# **3.1** BLOCK B SUB-STATION LOUVRE

## **3.2** BLOCK A SUB-STATION LOUVRE

St Ermins Property Company Limited Project 44 Gloucester Avenue London NW1 8JD	Architecture Ltd	Twenty First Archite 314 Goswell Road, London, EC1V 7AF Tel: +44(0)20 7952 02 www.21starchitectur	252
	Drawing Title Proposed Condition Detail Drawings	Status Planning	Drawn HF	Checked TJS
•		Scale 1:20 @ A1, 1:40 @ A3		Date Mar 2019
$\left[ \right]$		Drwg. No. 173_PL-CONE	0_03b_04	Revision P2

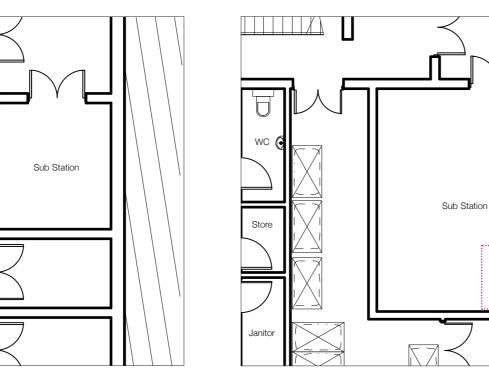
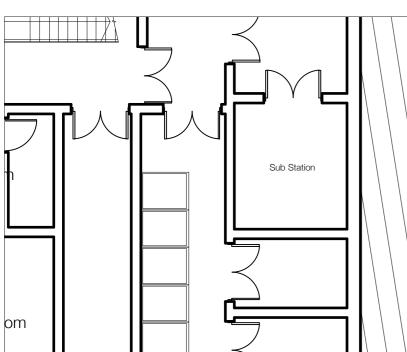
Following the consented amendment in application 2016/5890/P, we have received further design guidance from UKPN which we have had to incorporate. As such, the sub-station room on basement level has increased which has meant that other parts of the layout have been amended accordingly.

In addition, the ventilation strategy has been amended to redirect the extraction into the courtyard, following concerns associated with extracting by the Block B entrance. This has resulted in a louvre being added in replacement of a balcony facing the courtyard.

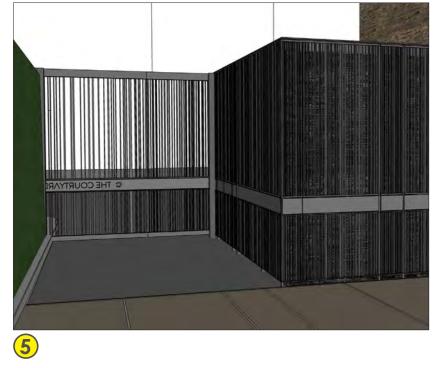
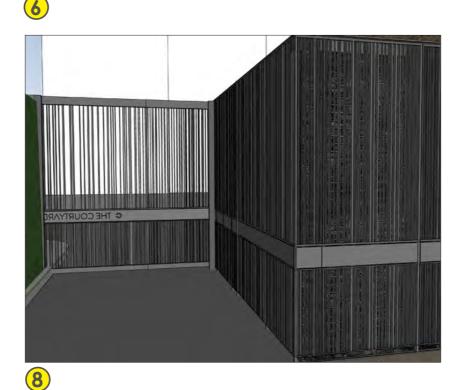
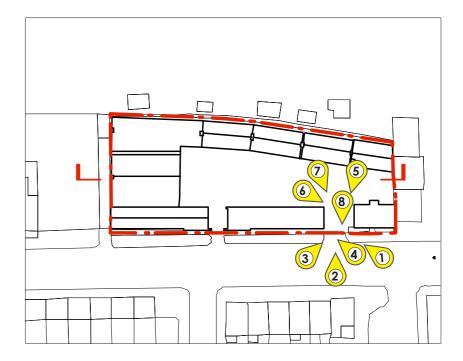
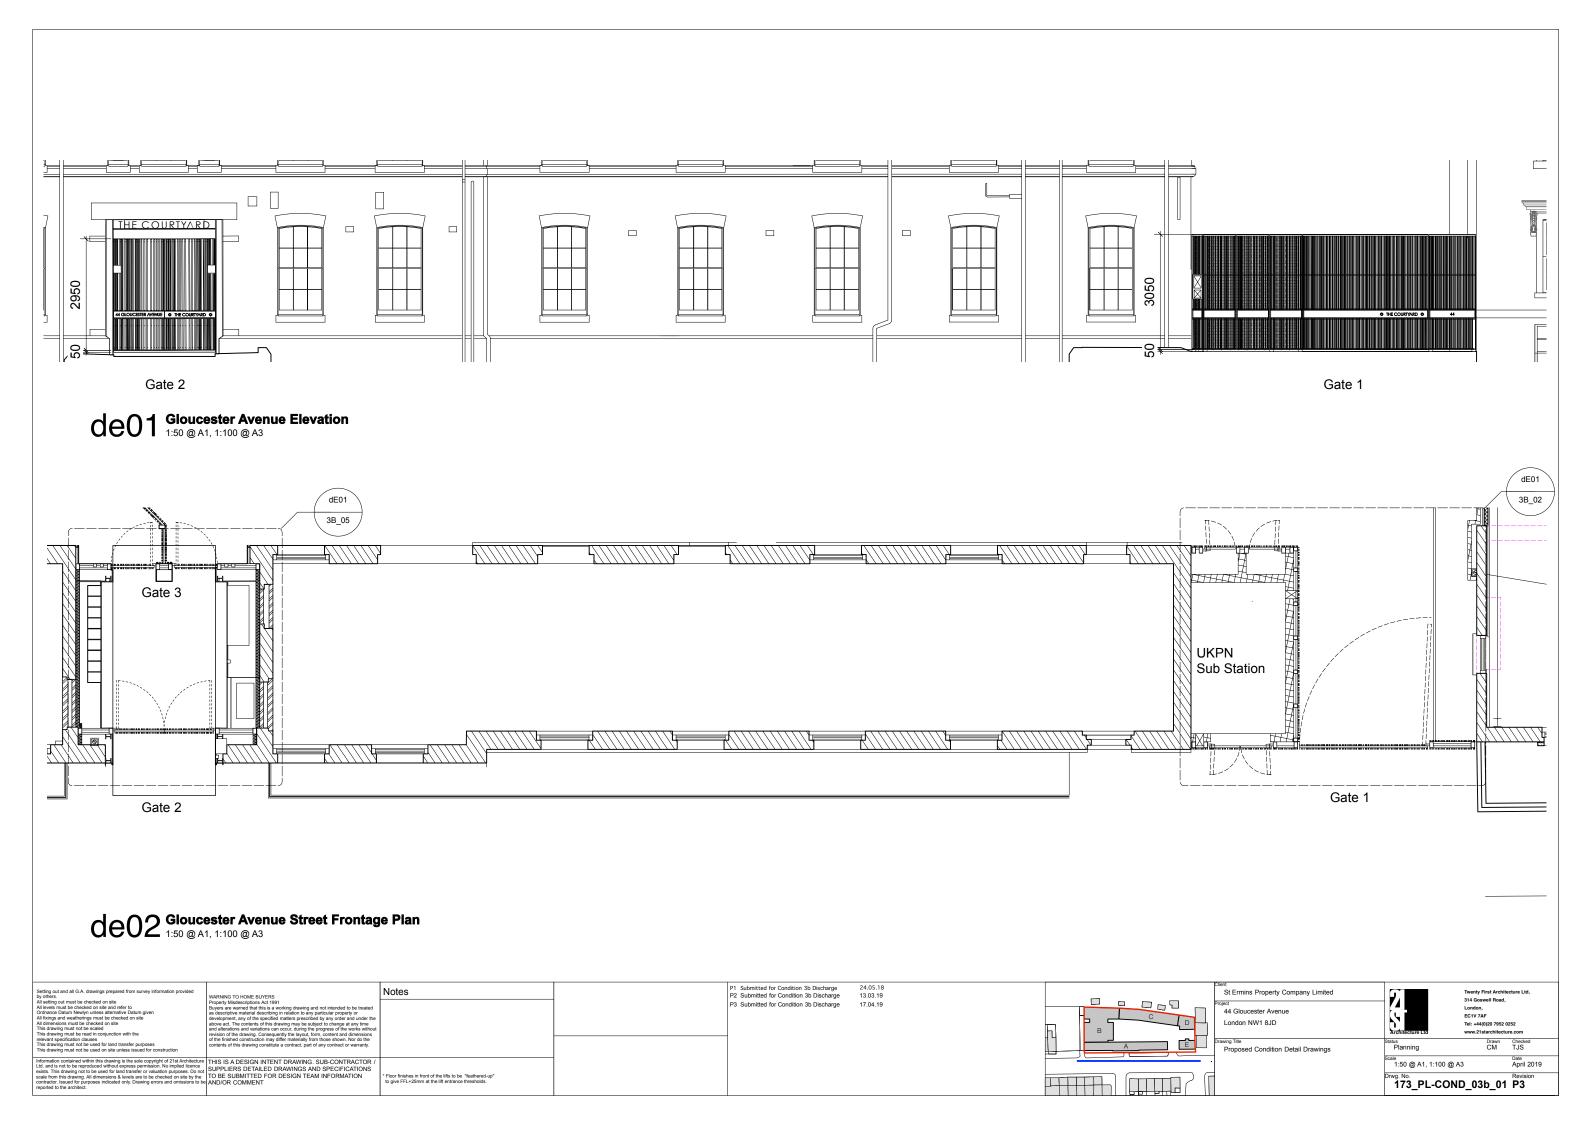
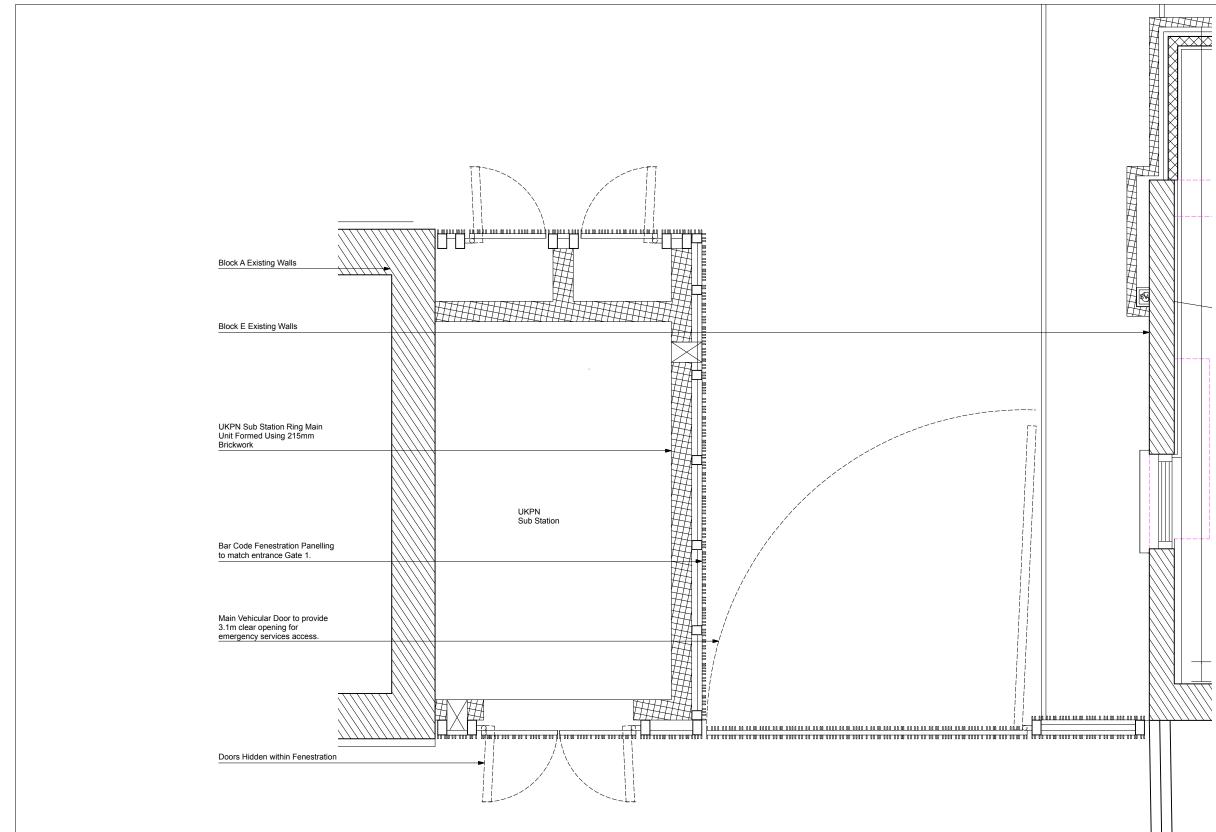
Following an enforcement letter further information was requested on the detailing of the brick sub-station and cladded enclosure.

In response to this concern 3D images have been provided to show the extent of the sub-station views through the open louvres.

In addition the sub-station brickwork is to be painted black to help conceal its image behind the louvres. The height of the louvres have also been amended in to 3100mm in order to ensure the sub-station is concealed.
